SUNDRY NOTICES AND REPORTS ON WELLS (DO NOT USE THIS FORM FOR PROPOSALS TO DRILL OR TO DEEPEN OR PLUG BACK TO A DIFFERENT RESERVOIR. USE "APPLICATION FOR PERMIT" (FORM C-101) FOR SUCH PROPOSALS.)		WELL API NO. 30-045-38317

2. Name of Operator SIMCOE LLC		6. State Oil & Gas Lease No. NMNM03358
3. Address of Operator 1199 MAIN AVE., STE #101, DURANGO, CO 81301		7. Lease Name or Unit Agreement Name NORTHEAST BLANCO UNIT

SIMCOE LLC is requesting to extend the Surface Casing to 3,601' TVD.

Sundry ID: 2750475

Wellbore Schematic

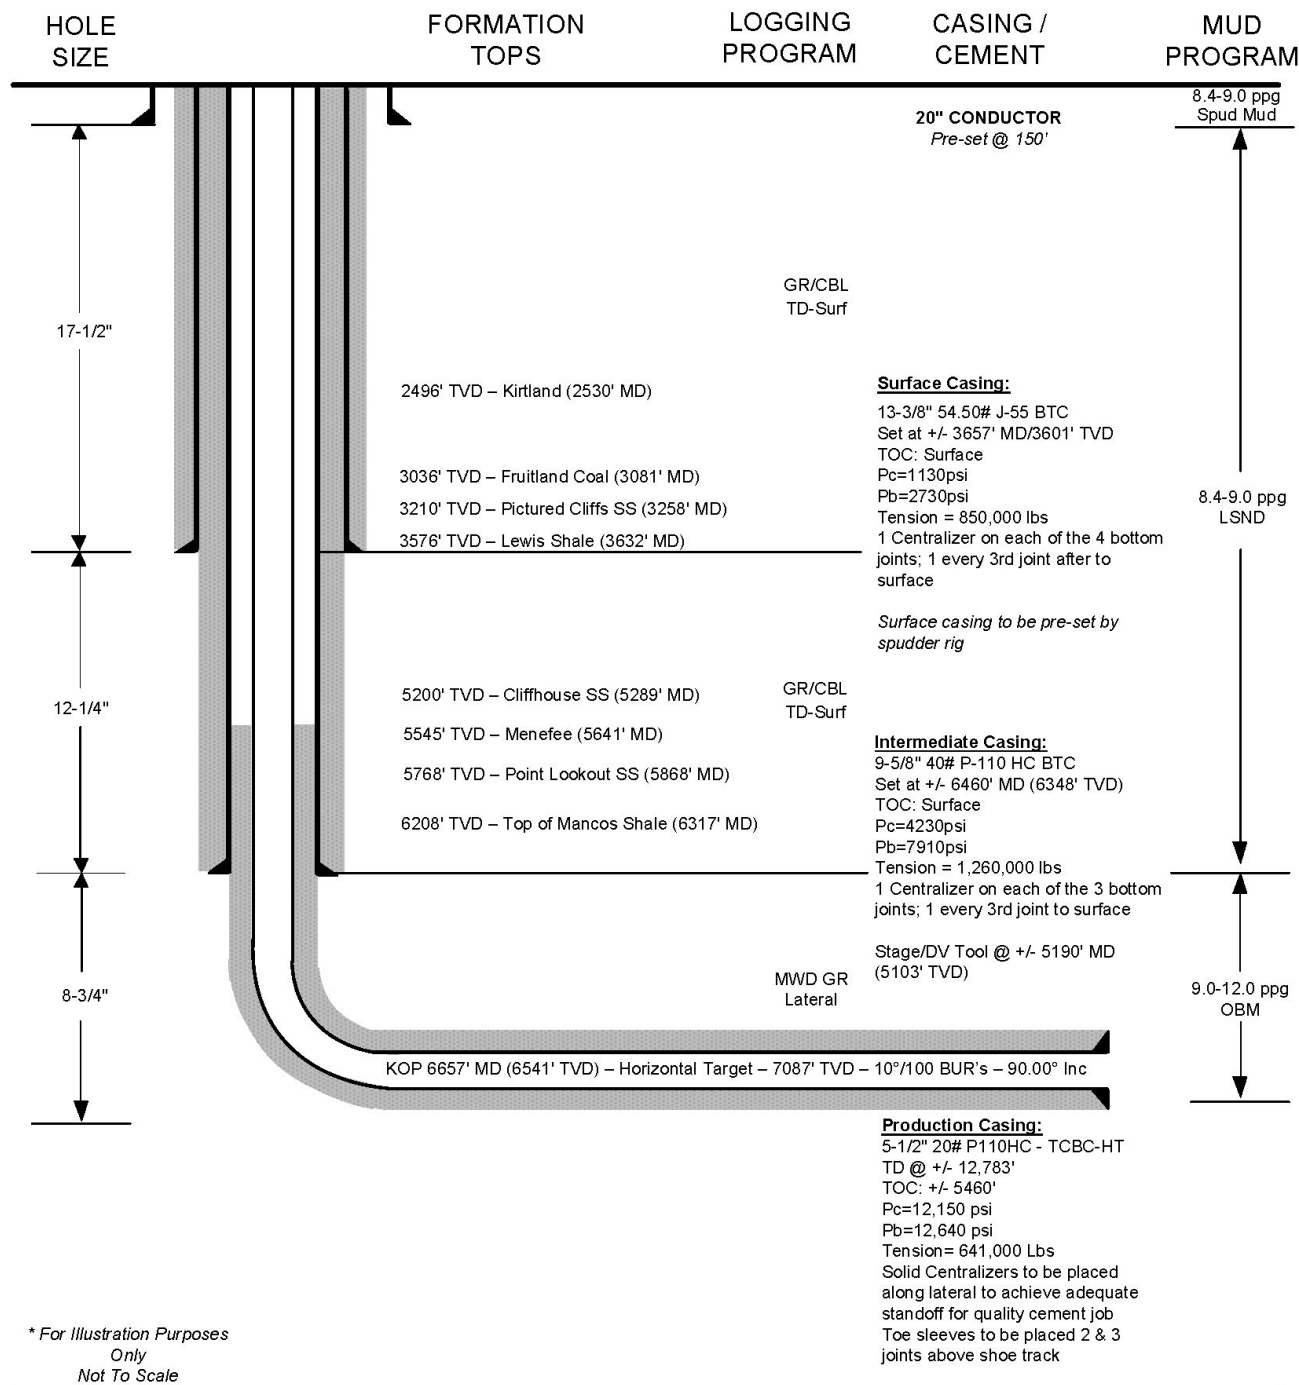
Current Surface Casing Program (as approved in the APD):

Casing size 13-3/8" set at ±1100' TVD; conventional cement job (1 stage), circulated to surface.

Revised Surface Casing Program:

Casing size 13-3/8" set at ±3601' TVD (roughly 25' into the Lewis Shale); conventional cement job (1 stage), circulated to surface.

To mitigate expected lost circulation problems in previously designed long (±5500' MD), deviated intermediate casing section; extreme lost circulation encountered both in offset operator's wells in addition to historic BP NEBU wells; will allow depleted intervals in Kirtland, Fruitland Coal, & Pictured Cliffs to be isolated behind pipe (surface casing) before drilling into the known depleted intervals in the Mesa Verde section; setting surface casing deeper (into the Lewis) allows for improved drilling efficiency & also increases the safety of drilling operations through these depleted sections.

No change to the Conductor, Intermediate and Production casing from the original approved casing program. Please see attached NEBU 602-7H Updated Casing Safety Cement Program for details.

1. Surface casing must be always at a minimum half fluid fill.

Wellbore Schematic

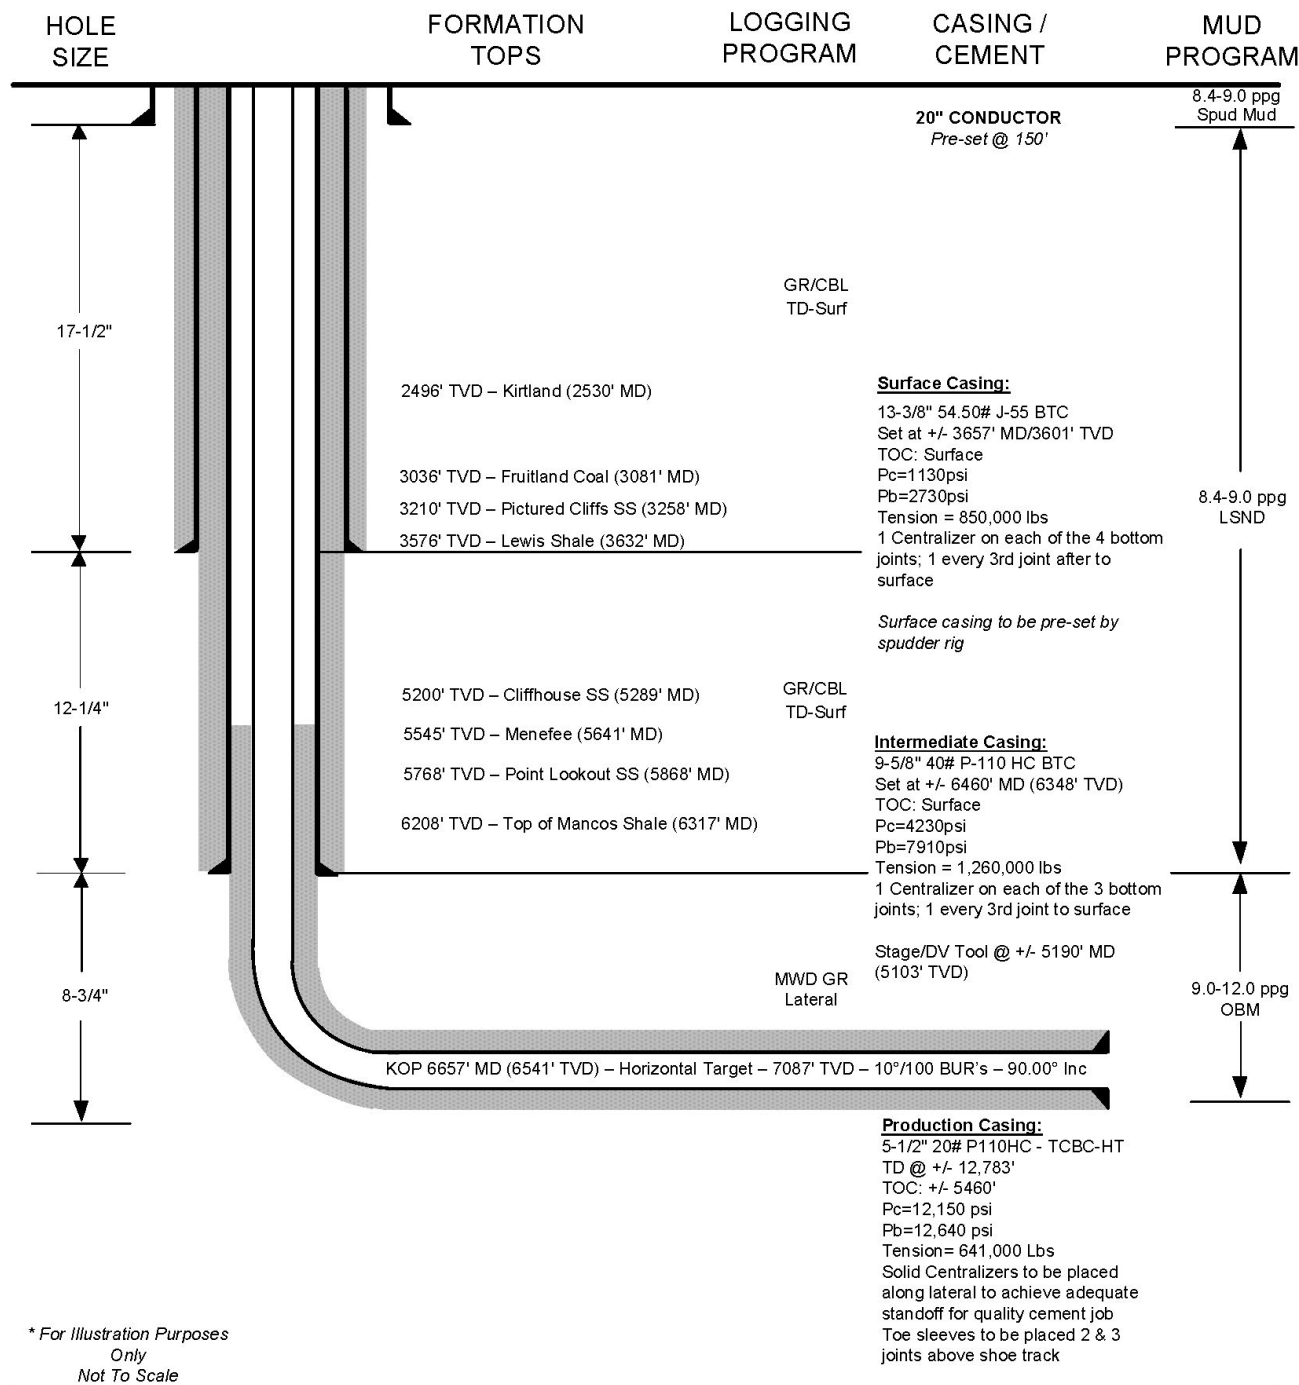
Reasons for setting deeper surface casing.

- to mitigate expected lost circulation problems in previously designed long (5500 MD), deviated intermediate casing section
- extreme lost circulation encountered both in offset operators wells in addition to historic BP NEBU wells
- will allow depleted intervals in Kirtland, Fruitland Coal, & Pictured Cliffs to be isolated behind pipe (surface casing) before drilling into the known depleted intervals in the Mesa Verde section
- setting surface casing deeper (into the Lewis) allows for improved drilling efficiency & also increases the safety of drilling operations through these depleted sections

Please see attached NEBU 602-7H Revised Casing and Cement Program for details.

1. Surface casing must be always at a minimum half fluid fill.
